ADDENDUM NO. 4:

Date: February 13, 2026
 Project: Verbena HS Gym
 DCM# 2025629
 WSM# 25-032

Owner: Chilton County Board of Education
 Architect: Ward Scott Morris Architecture, Inc.

PROJECT: Verbena HS Gym	ENG #2559 ARCH #25-032 DCM #2025629	DATE: February 13, 2026
-----------------------------------	---	-----------------------------------

4 TICKET BOOTH - LIGHTING PLAN
1/4" = 1'-0"

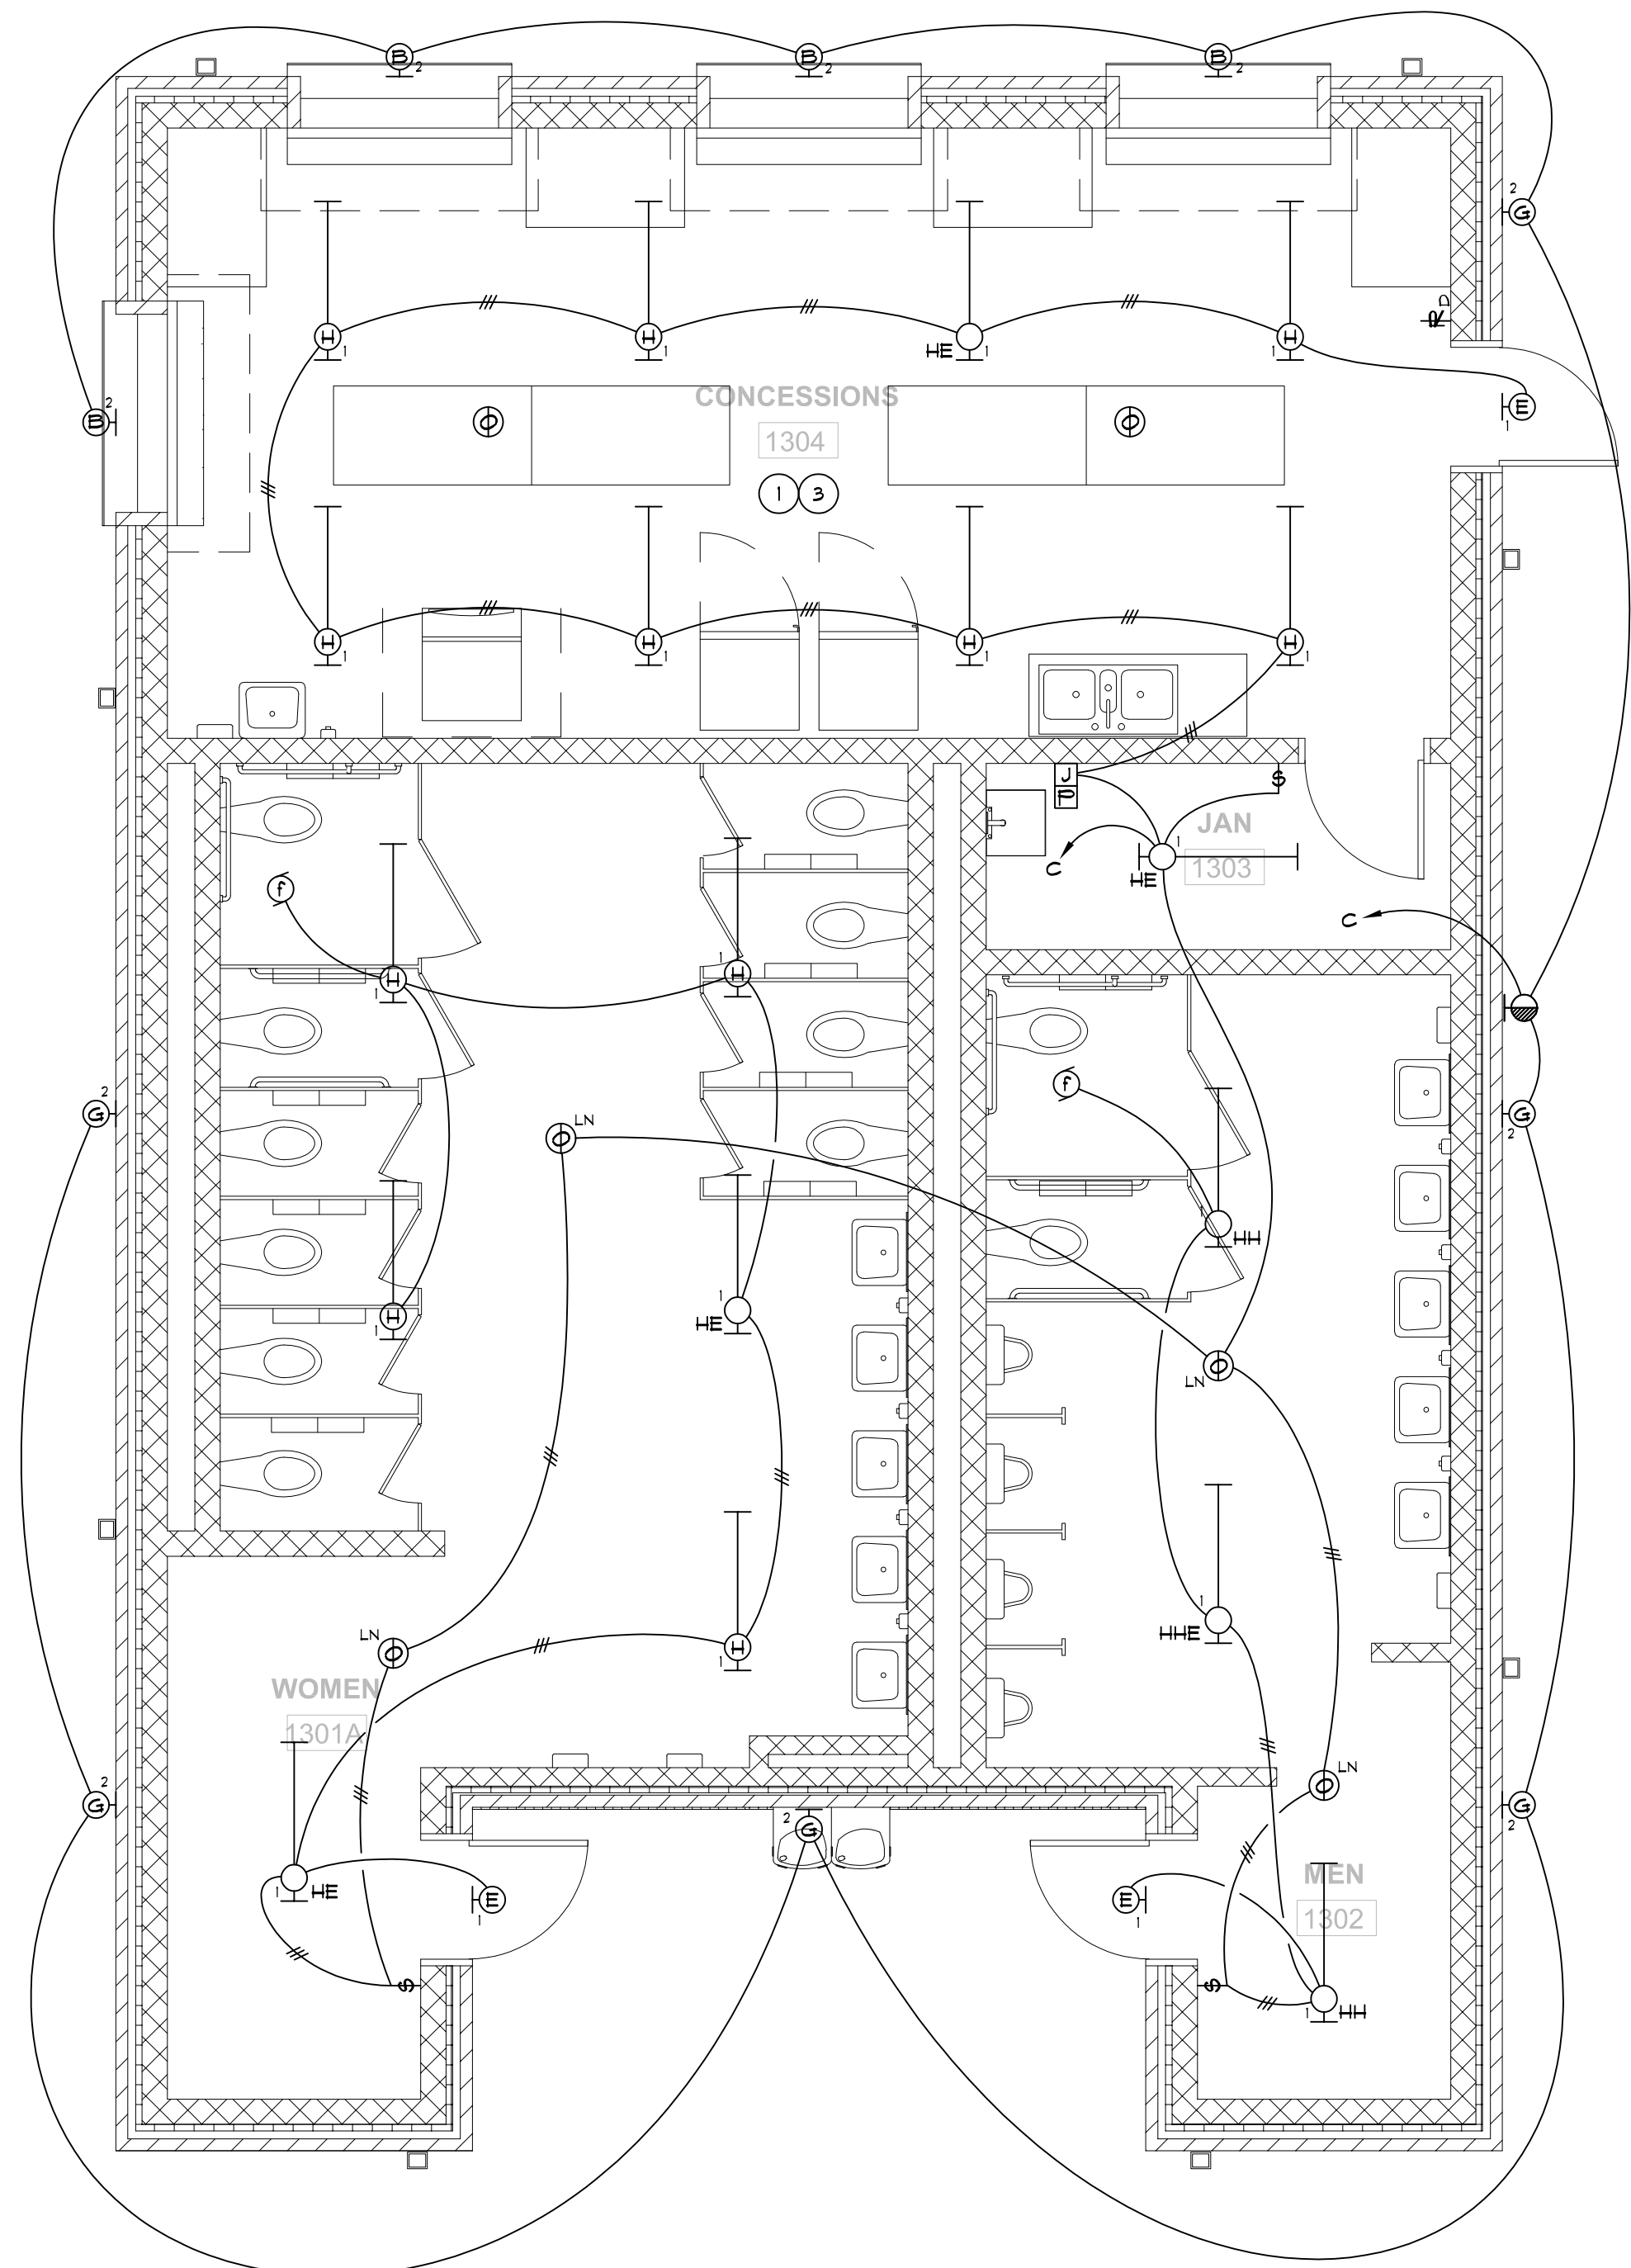
- e. Restroom Building – Power Wiring Plan, Jan 1303: Connection to circulator pump removed
4. Sheet E201, Gymnasium – Lighting Plan:
 - a. Elec 1104: 'S4' luminaire removed

- b. Storage 1105: 'F4L' luminaire and additional wall switch added

C201

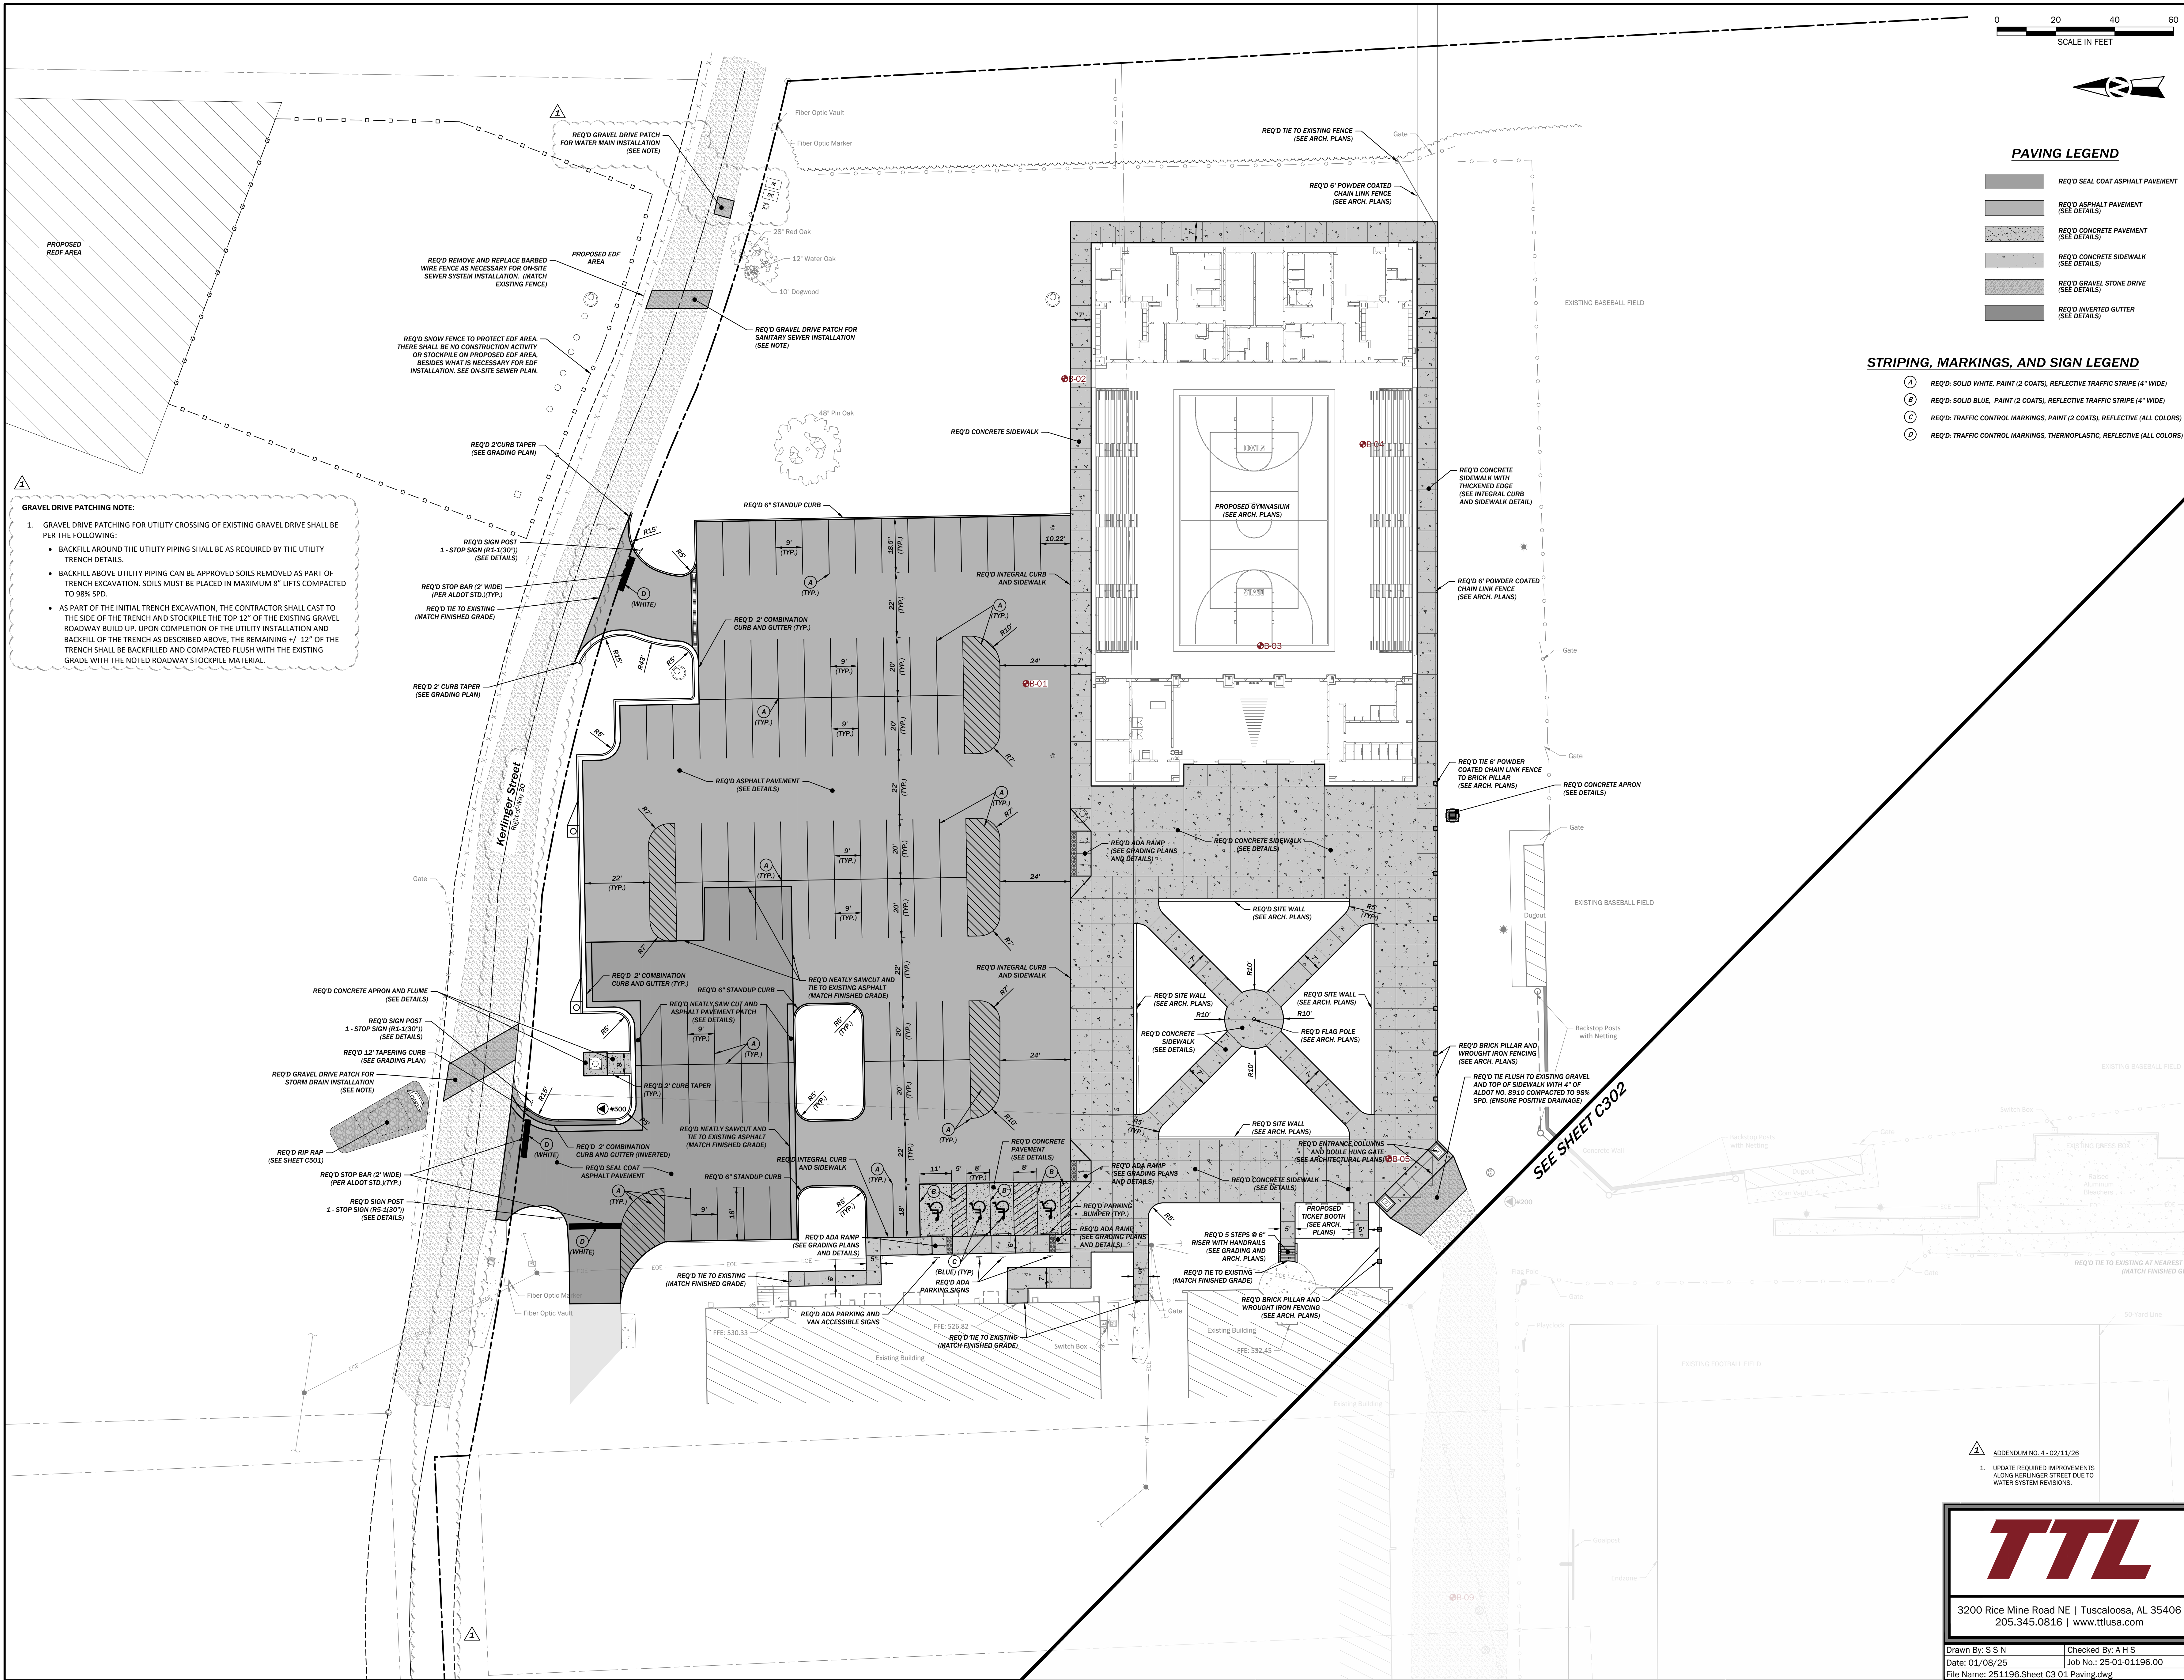
- ADDENDUM NO. 4 - 02/11/26
1. UPDATE REQUIRED IMPROVEMENTS ALONG KERLINGER STREET DUE TO WATER SYSTEM REVISIONS.
 2. UPDATE CLEARING LIMITS REQUIRED FOR EFFLUENT DISPOSAL FIELD.
